Preliminary and Final Drainage Letter

7-Eleven Store #42975

SWC Bradley Road and Legacy Hill Drive
Colorado Springs, CO 80829
Lot 1, Waterview East Commercial Subdivision, Filing No. 1
Submitted: April 24, 2026

Final Drainage Letter

Rectangular Weir

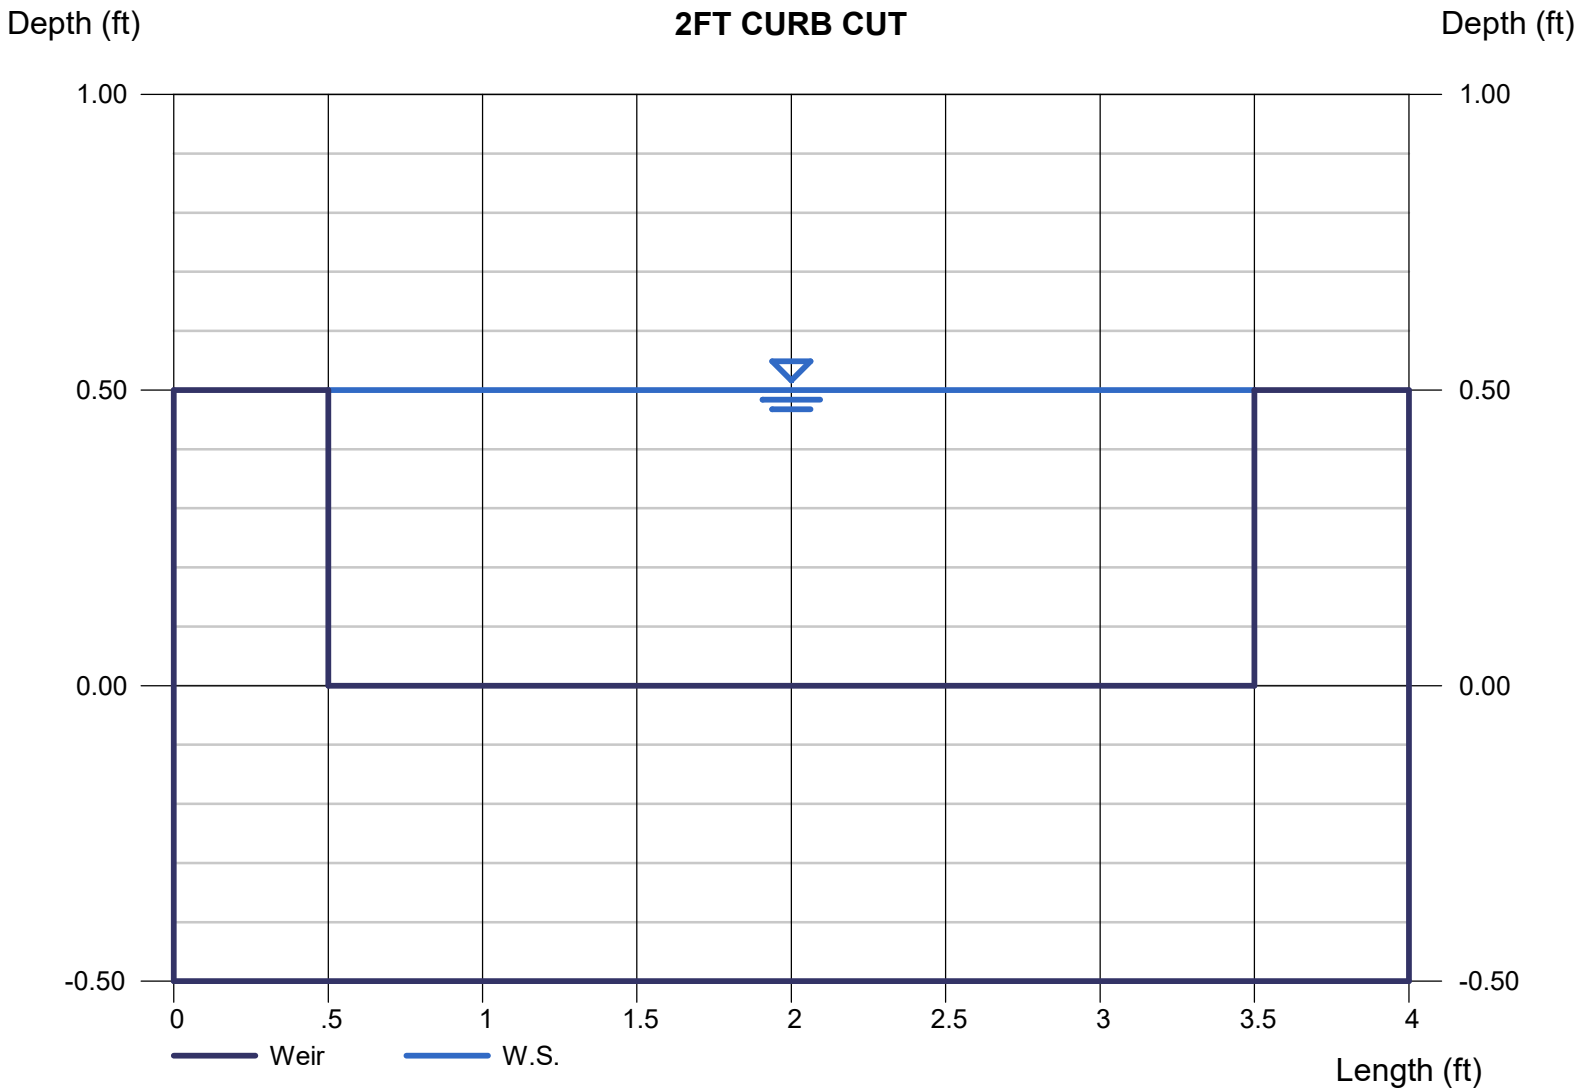
this is labeled 2-ft curb cut in the plans, but this calculation is for a 3-ft curb cut. Revise.

Profile Report

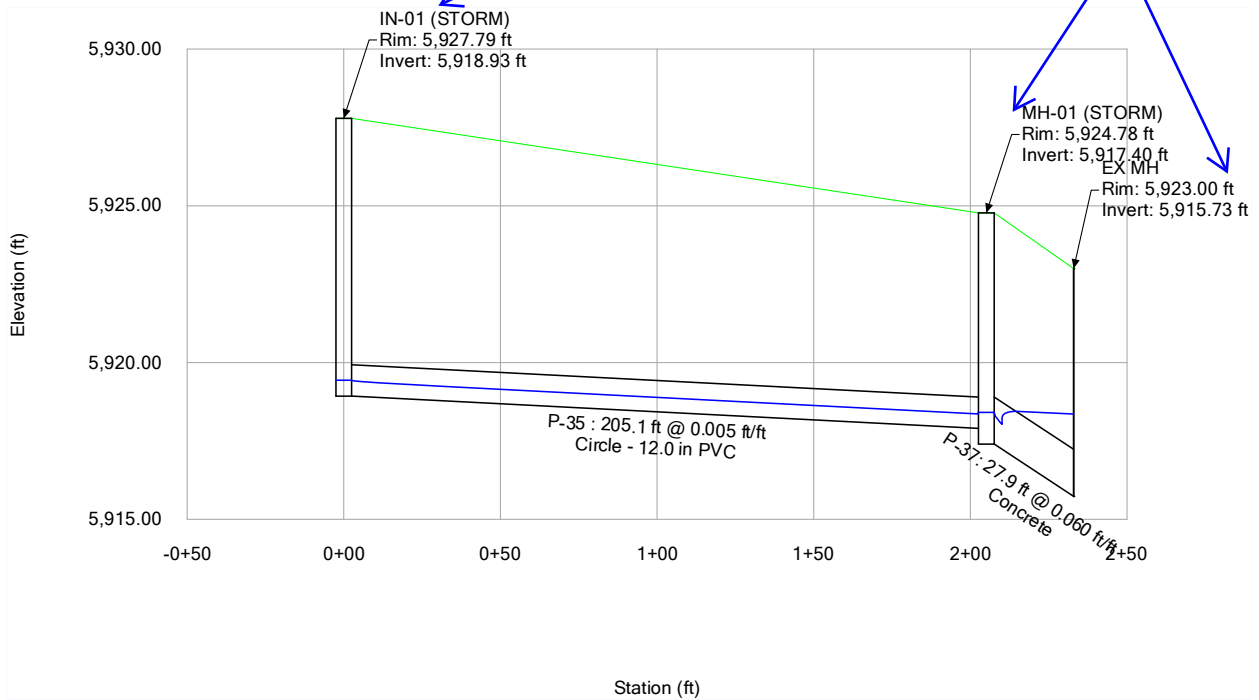
Rim and invert elevations do not match what are depicted in the plans. Revise.

Engineering Profile - IN-02-EX MH (STORM.stsw)

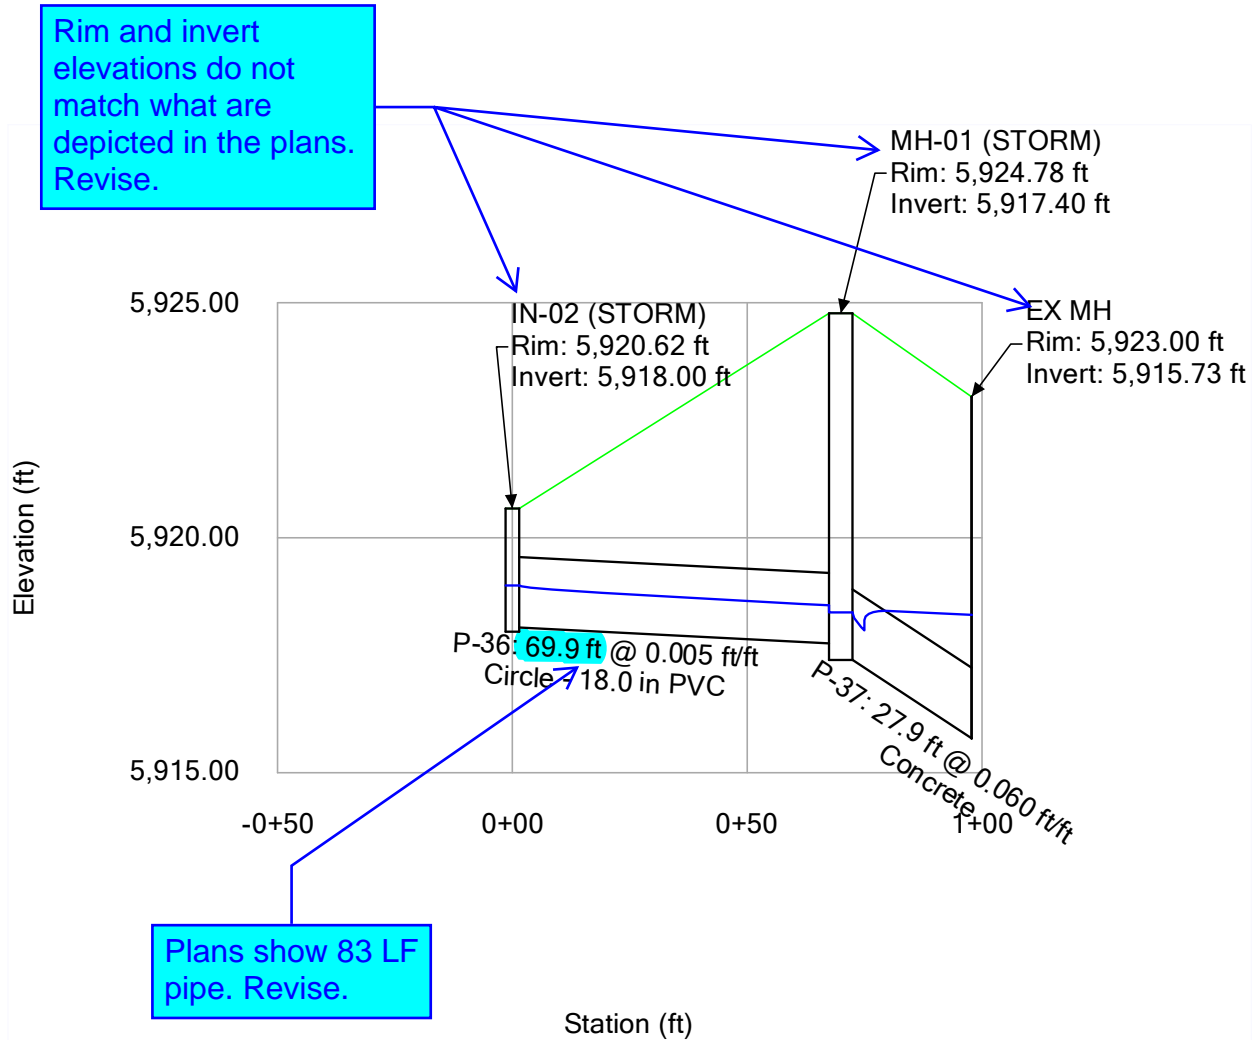
Rim and invert elevations do not match what are depicted in the plans. Revise.

Engineering Profile - IN-02-EX MH (STORM.stsw)

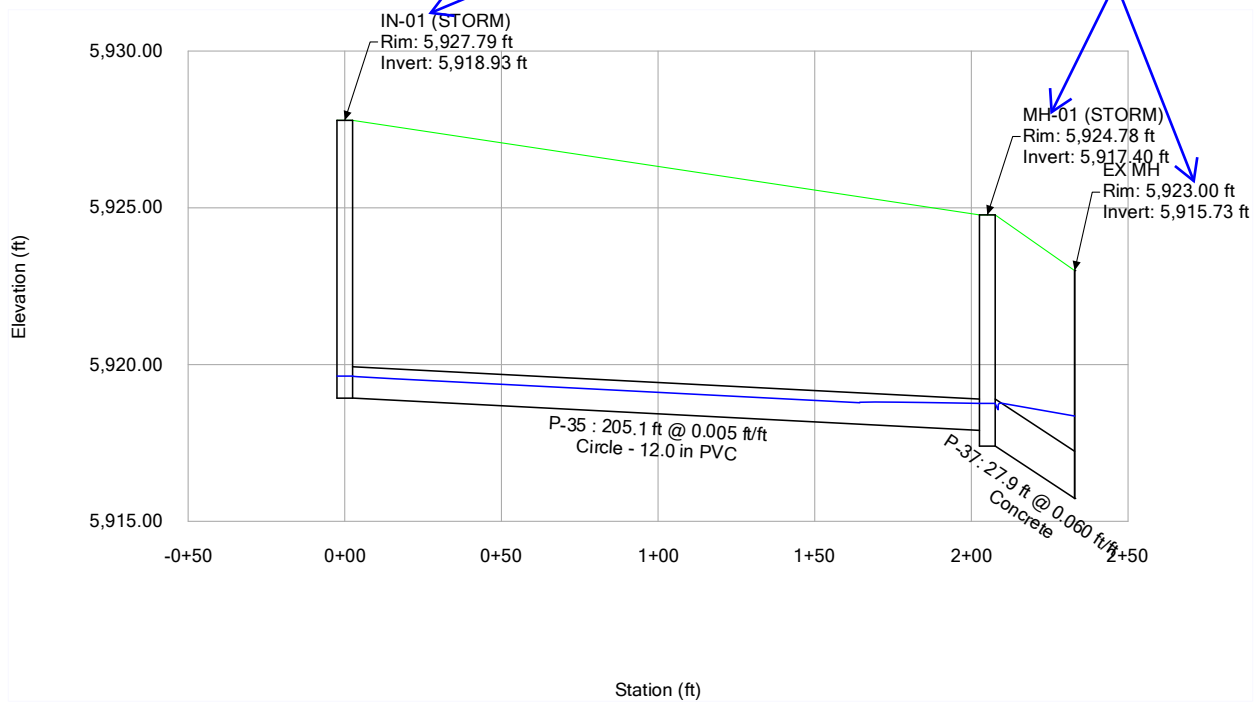
Rim and invert elevations do not match what are depicted in the plans. Revise.

MAJOR SITE DEVELOPMENT PLAN
7-ELEVEN - STORE #42975
SITE #1057022
 BRADLEY ROAD AND LEGACY DRIVE
DEVELOPED DRAINAGE MAP

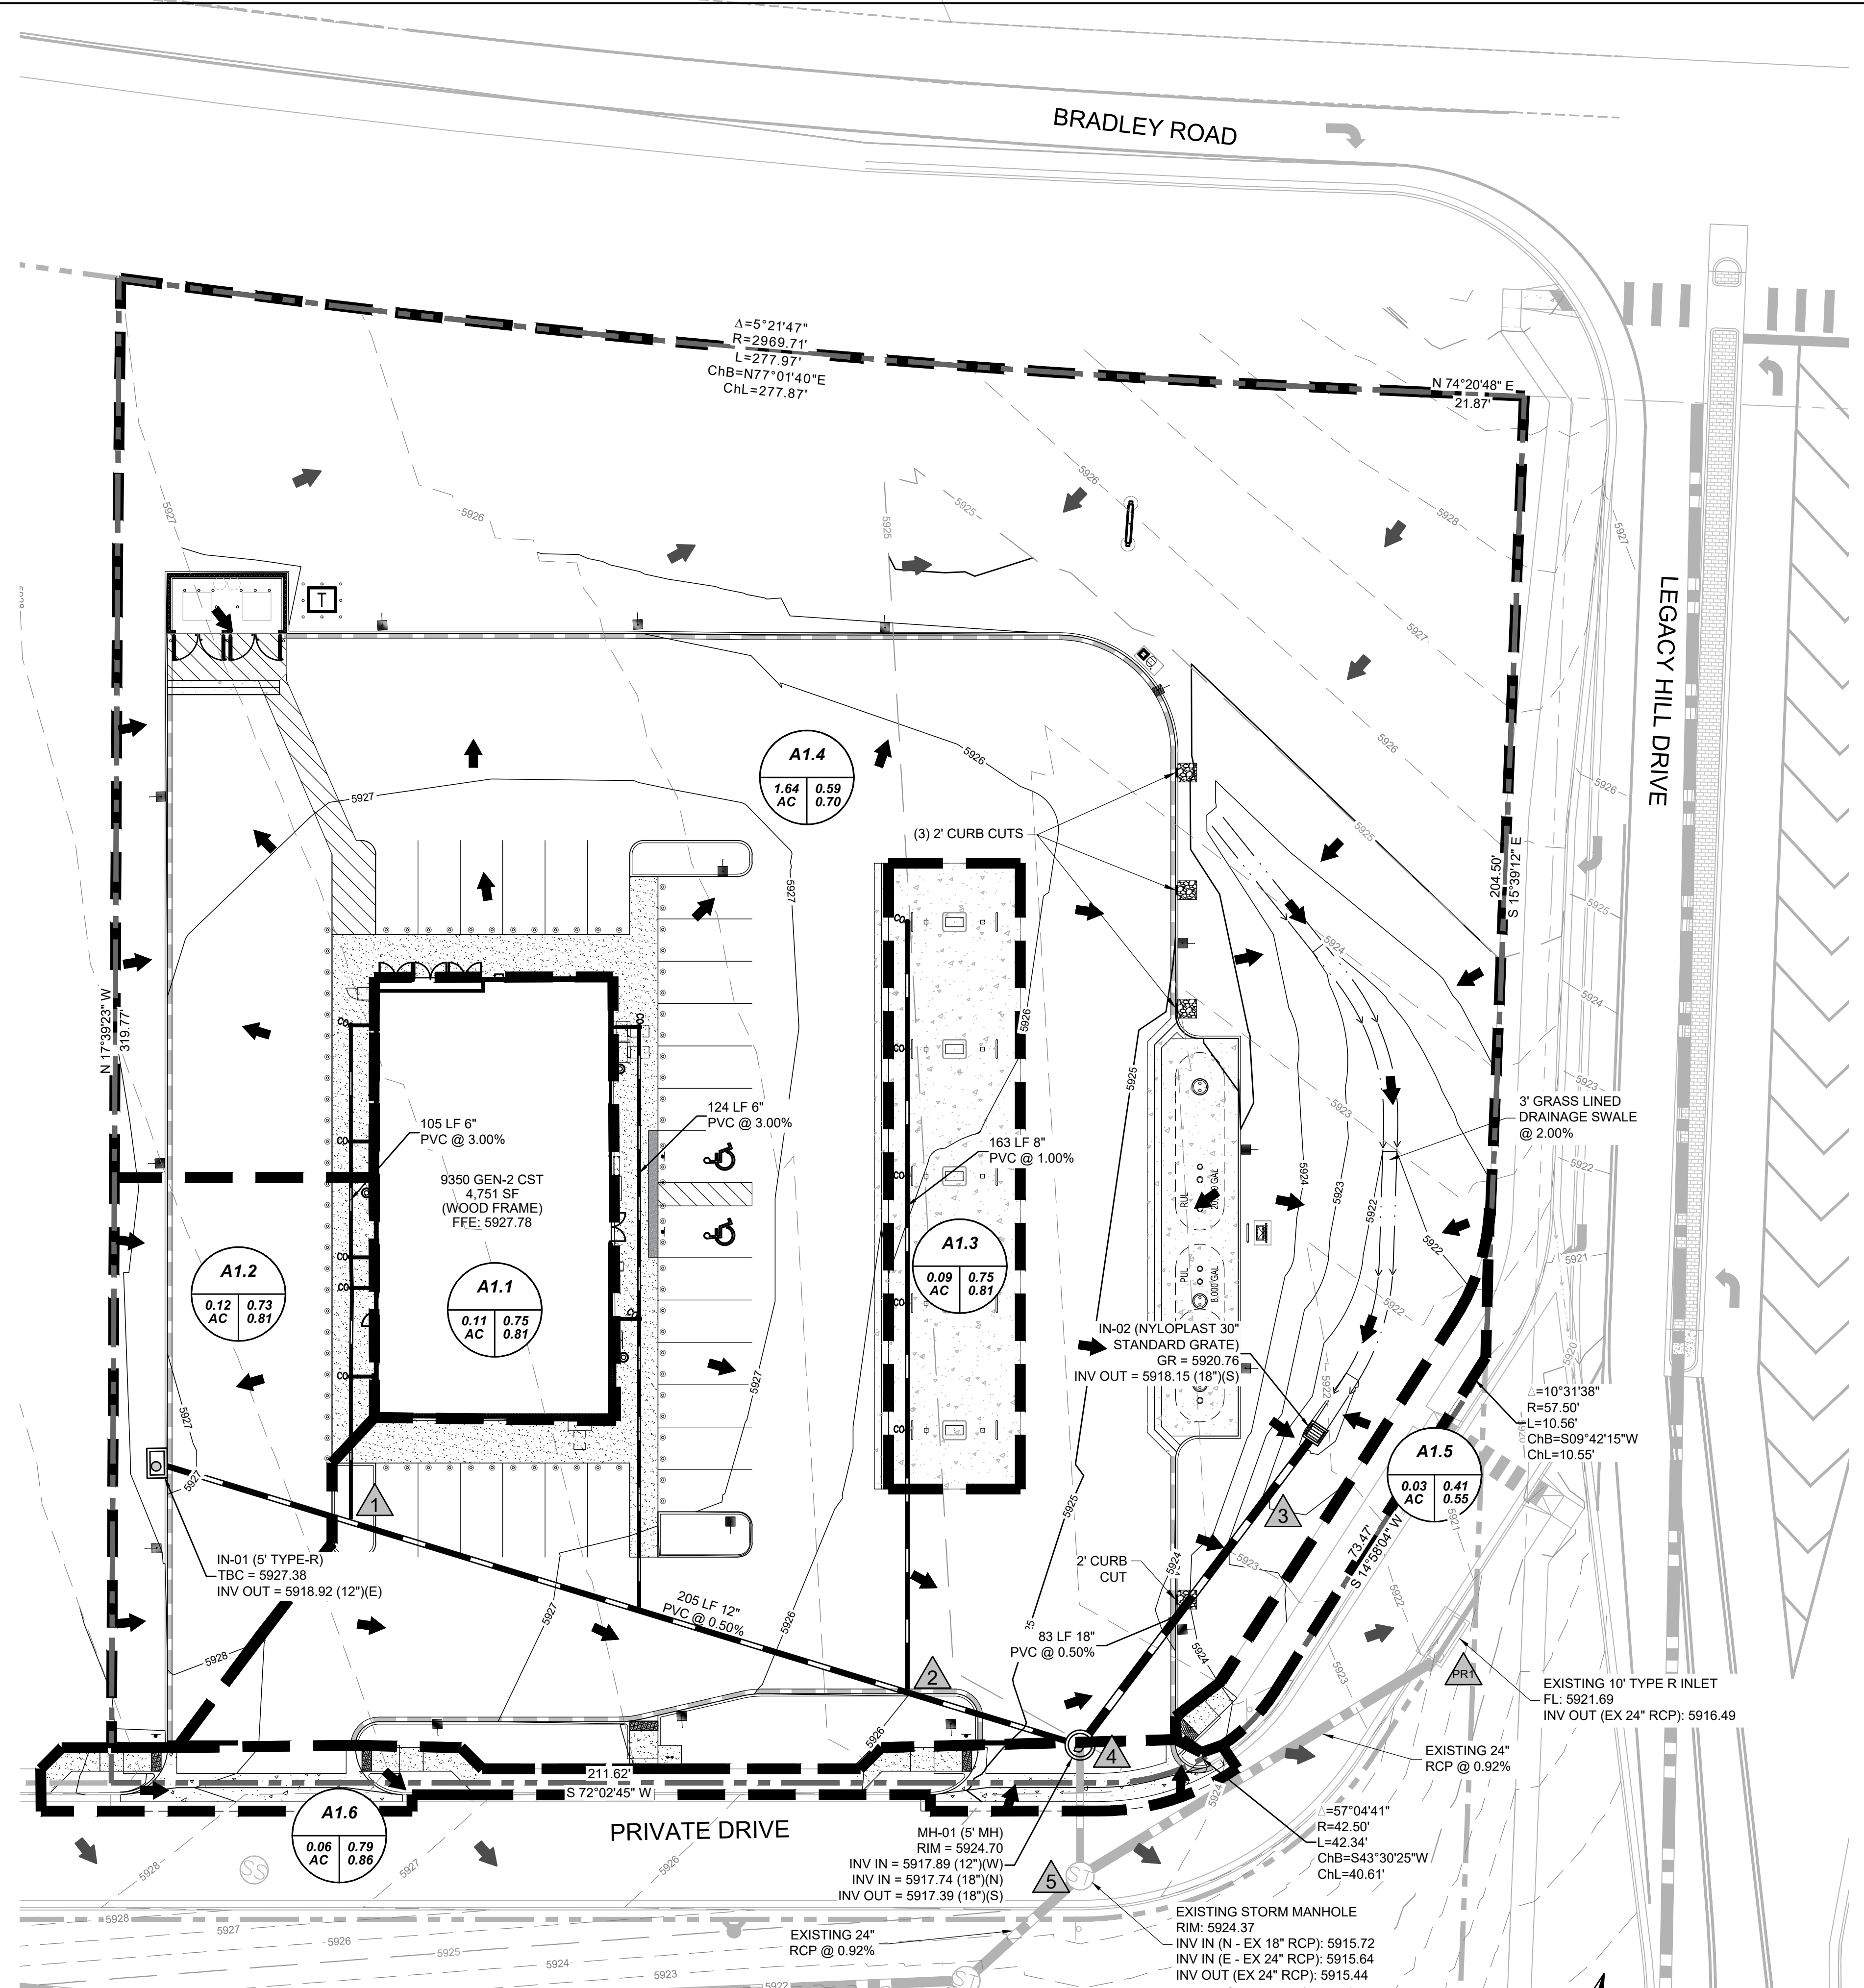
Remove signature blocks from drainage map.

Remove
